Intel® 80219 General Purpose PCI Processor

Specification Update

July 2004

Document Number: **274020-002**

Figure 2. Intel® 80219 General Purpose PCI Processor P_BMI Signal Implementation for Intel® 80219 General Purpose PCI Processor B-0/B-1 Stepping

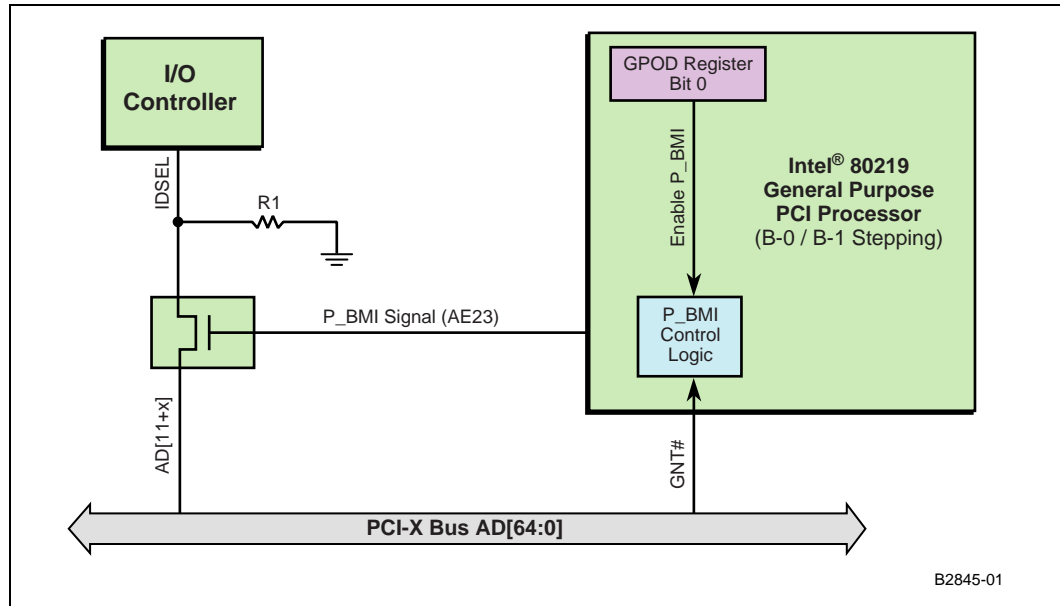
1. Signal NC2 was renamed to P_BMI (AE23). New function added to signal P_BMI.

The P_BMI (AE23) signal has been added to the Intel® 80219 general purpose PCI processor. This signal replaces, using an external GPIO pin for Initialization Device Select (IDSEL) control of an I/O device during host configuration cycles.

The 80219 has eight integrated General Purpose Input Output (GPIO) pins, referred to as GPIO[7:0]. These pins, along with the new PCI-X Bus Master Indicator (P_BMI) signal, can be used to control the IDSEL to the I/O device. External circuitry is no longer required other than a simple switch. The output function of the P_BMI signal is controlled by the GPIO Output Data Register (GPOD), Bit 0 as shown in Table 1. The P_BMI signal is always driven and defaults to driving low at power up.

The IDSEL signal is used as a chip select during configuration cycles initiated by the BIOS, operating system or 80219. The GPOD[0] can be driven low in firmware, thereby disabling the P_BMI signal and hiding the host I/O device from the system, by turning off its IDSEL. When the 80219 intends to perform configuration cycles in the PCI bus segment of the I/O device, the P_BMI signal should be asserted high by driving the GPOD[0] high. The affect of these two operations is, that the I/O device is initialized and controlled by the 80219. More care must be taken with the gate chosen to control IDSEL, since most host bridge controllers do not use PCI address stepping. With IDSEL being a synchronous signal, with respect to CLK, the switch used must be a sub nanosecond propagation delay device (e.g., Pericom PI5C3303). In Figure 2, the P_BMI signal is used to control a MUX/DeMUX switch that is used to enable/disable IDSEL to the I/O device.
